Technical Service Bulletin

November 17, 2015

TSB0516
Sprocket Shims

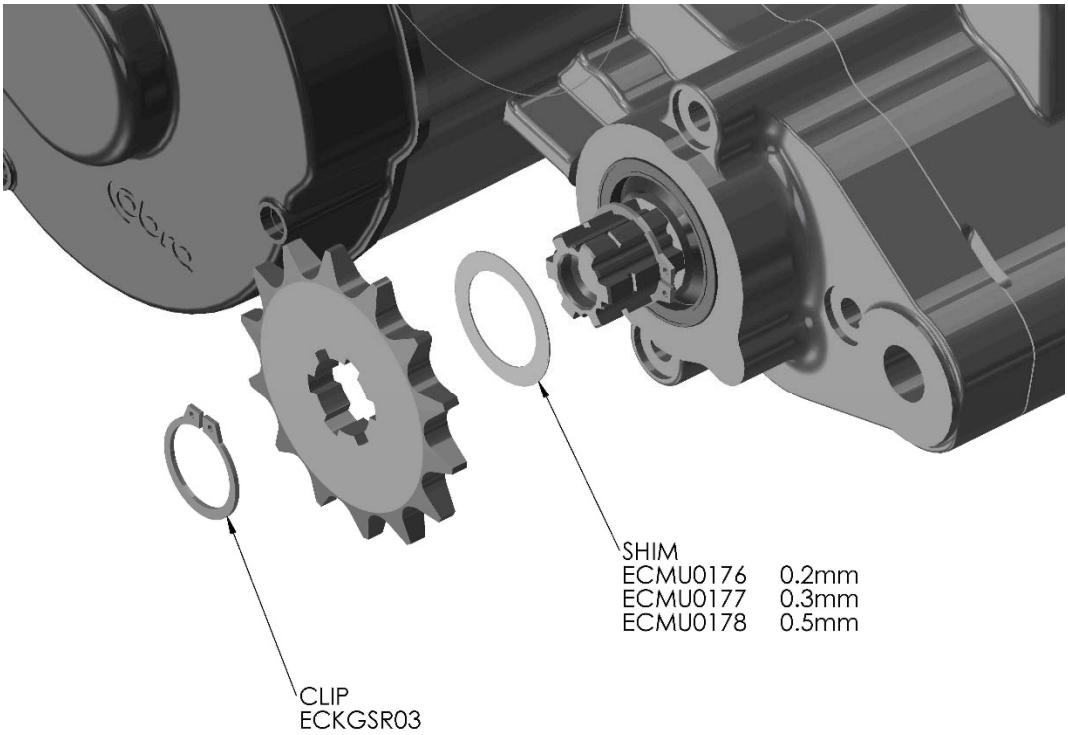
For 2016 CX50 models may have shims behind the countershaft sprocket that tighten up the fit. These shims are available in three different thicknesses to account for wear and different sprocket thicknesses.
